UNITED STATES PATENT AND TRADEMARK OFFICE

APPLICATION NO.	FILING DATE	FIRST NAMED INVENTOR	ATTORNEY DOCKET NO.	CONFIRMATION NO.
10/707,006	11/13/2003	Abdelaziz Ikhlef	GEMS 0215 PA	1005
27256	7590	03/30/2006	EXAMINER	
ARTZ & ARTZ, P.C. 28333 TELEGRAPH RD. SUITE 250 SOUTHFIELD, MI 48034			HO, ALLEN C	
			ART UNIT	PAPER NUMBER
			2882

Office Action Summary	Application No. 10/707,006	Applicant(s) IKHLEF, ABDELAZIZ	
	Examiner Allen C. Ho	Art Unit 2882

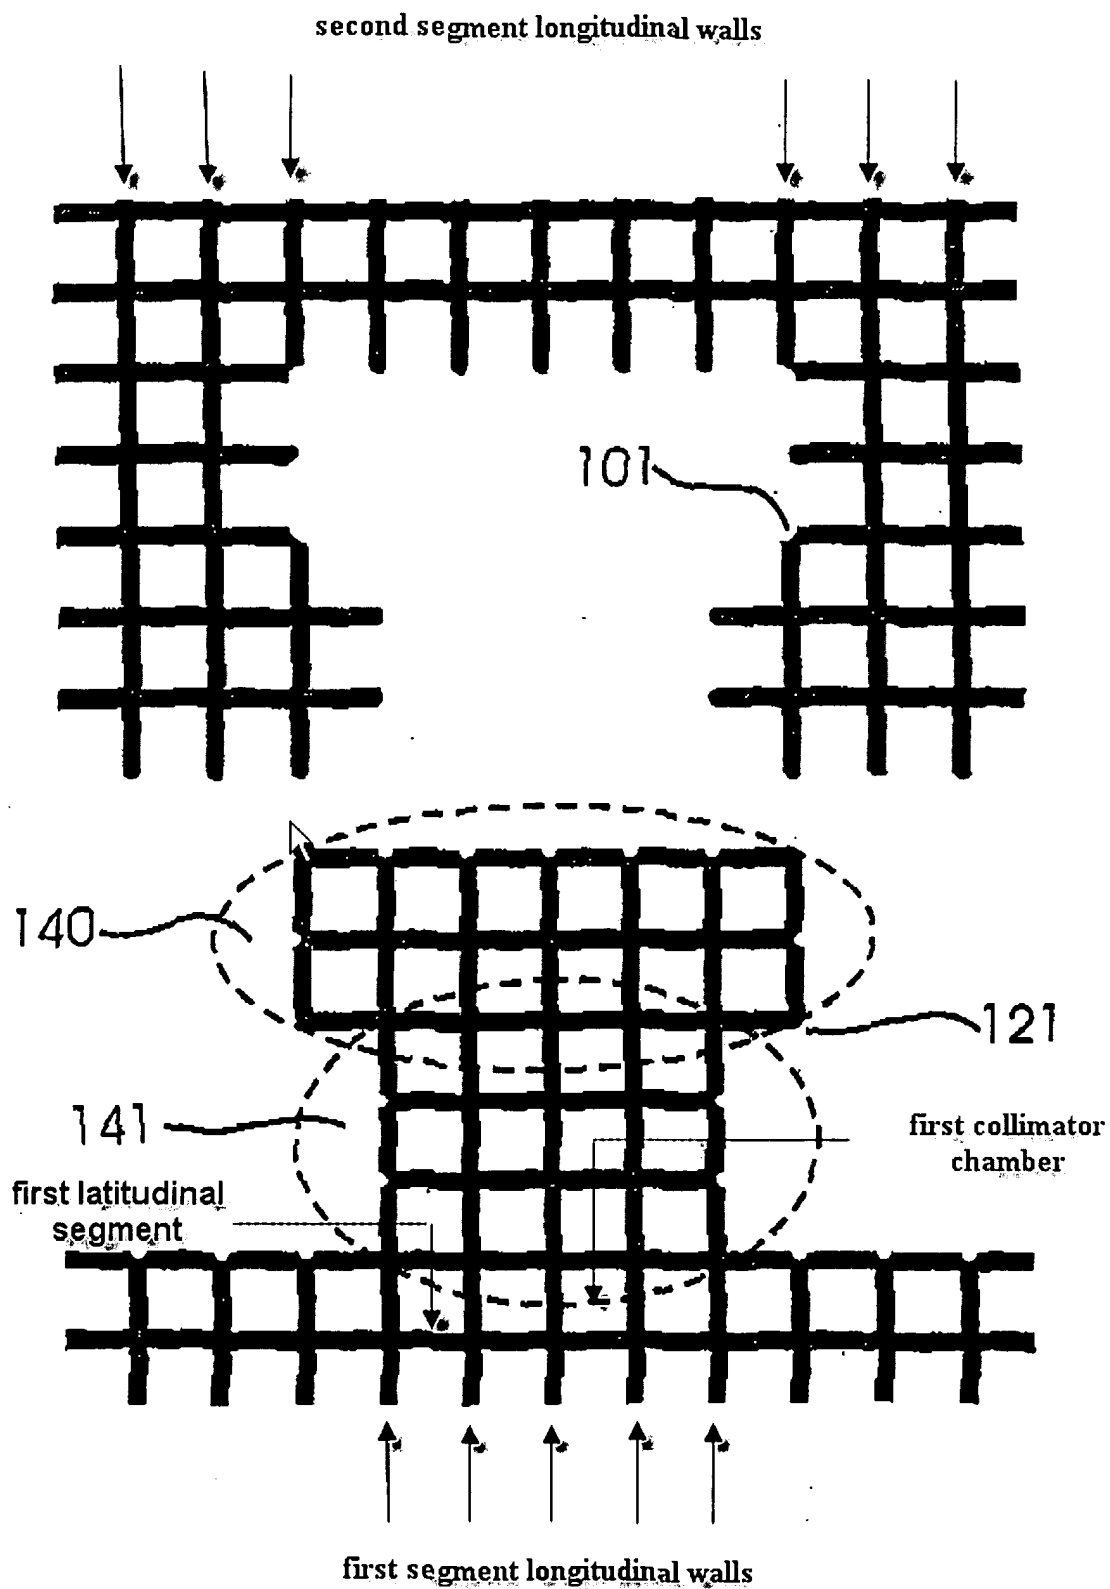
With regard to claim 1, Tang disclosed a detector assembly comprising: a collimator assembly (30) comprising:

a first collimator segment (120) having a first left end and a first right end, the first collimator segment comprising: a plurality of first segment longitudinal walls having a first segment depth, each of the plurality of first segment longitudinal walls including a first locking protrusion (140, 141) comprising only a portion (the entire portion) of the first segment depth, the plurality of first segment longitudinal walls configured to be planar to projected x-rays; and

a second collimator segment (100) having a second left end and a second right end, the second collimator segment comprising: a plurality of second segment longitudinal walls having a second segment depth, each of the plurality of second segment longitudinal walls including a second interlocking protrusion (103) comprising only a portion (the entire portion) of the second

segment depth, each of the second interlocking protrusion engaging one of the first interlocking protrusions to form a continuous side wall segment; and

a plurality of first latitudinal segments positioned between each of the plurality of first longitudinal walls such that a plurality of first collimator chambers is formed, each of the first collimator chambers having a first collimator width (Fig. 4).

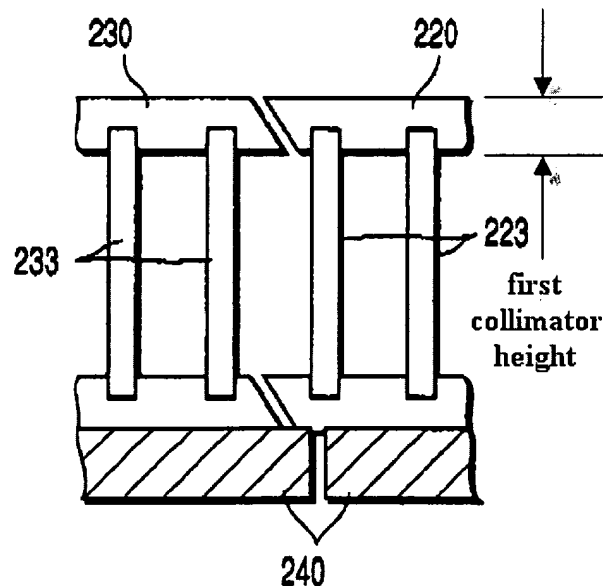
With regard to claim 1, Igarashi *et al.* disclosed a detector assembly comprising: a collimator assembly (Figs. 10A, 10B, 10C) comprising:

a first collimator segment (220) having a first left end and a first right end, the first collimator segment comprising: a plurality of first segment longitudinal walls (221, 222) having a first segment depth, each of the plurality of first segment longitudinal walls including a first locking protrusion (tapered shape) comprising only a portion (the entire portion) of the first segment depth; and

a second collimator segment (230) having a second left end and a second right end, the second collimator segment comprising: a plurality of second segment longitudinal walls (231, 232) having a second segment depth, each of the plurality of second segment longitudinal walls including a second interlocking protrusion (tapered shape) comprising only a portion (the entire portion) of the second segment depth, each of the second interlocking protrusion engaging one of the first interlocking protrusions to form a continuous side wall segment; and

a plurality of first latitudinal segments (223) positioned between each of the plurality of first longitudinal walls such that a plurality of first collimator chambers is formed, each of the first collimator chambers having a first collimator width.
